Access Compliance Report

Public Rights-of-Way

Intersection ID: 19152	Main Street: E_INDEPENDENCE_BV	Cross Street: VILLAGE_LAKE_DR	Location: E
ADA ID: 6A977B392ED6	Ramp Type: PerpDiag	Initial Pass/Fail: Fail	Overall Compliance: No
Severity Score: 12.5			
Codes/Mitigation Info/Possible Solution		Field Measurements/Component Compliance

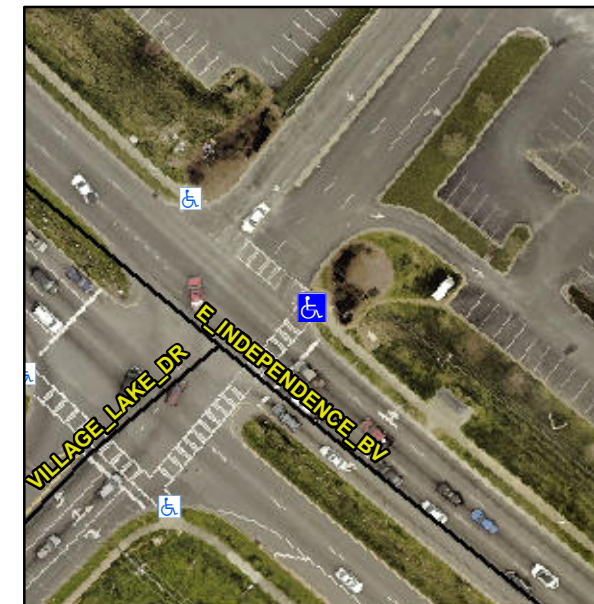
Not Found, R304.5.3

Compliance	Description	Data	Compliance	Description	Data
N/A	Ramp Length (in)	78.0	Yes	Ramp Slope (%)	7.1
Yes	Ramp Width (in)	50.0	No	Ramp XSlope (%)	6.0
N/A	Flare Type LT	N/A	N/A	Flare Type RT	N/A
N/A	Flare Slope LT (%)	N/A	N/A	Flare Slope RT (%)	N/A
N/A	Flare Traversable LT?	N/A	N/A	Flare Traversable RT?	N/A
N/A	Landing Length (in)	N/A	N/A	DWS Provided?	N/A
N/A	Landing Width (in)	N/A	N/A	DWS Contrast?	N/A
N/A	Landing Slope (%)	N/A	N/A	DWS Length (in)	N/A
N/A	Landing X Slope (%)	N/A	N/A	DWS Full Width?	N/A
N/A	Landing Curb? (Y/N)	N/A	N/A	DWS Offset (in)	N/A
N/A	Shared Landing?	N/A			
N/A	Gutter Ponding?	N/A	N/A	Gutter Slope (%)	N/A
N/A	Gutter Lip Ht (in)	N/A	N/A	Gutter X Slope (%)	N/A
N/A	Painted X Walk1?	Yes	N/A	Painted X Walk2?	Yes
	X Walk 1 Direction	To NW		X Walk 2 Direction	To SW
N/A	X Walk 1 Width (in)	112.0	N/A	X Walk 2 Width (in)	109.0
	X Walk 1 Slope (%)	0.8		X Walk 2 Slope (%)	0.6
	X Walk 1 X Slope (%)	3.8		X Walk 2 X Slope (%)	1.3

Remove & Replace Curb Ramp With Two New Directional Ramps or Equivalent.
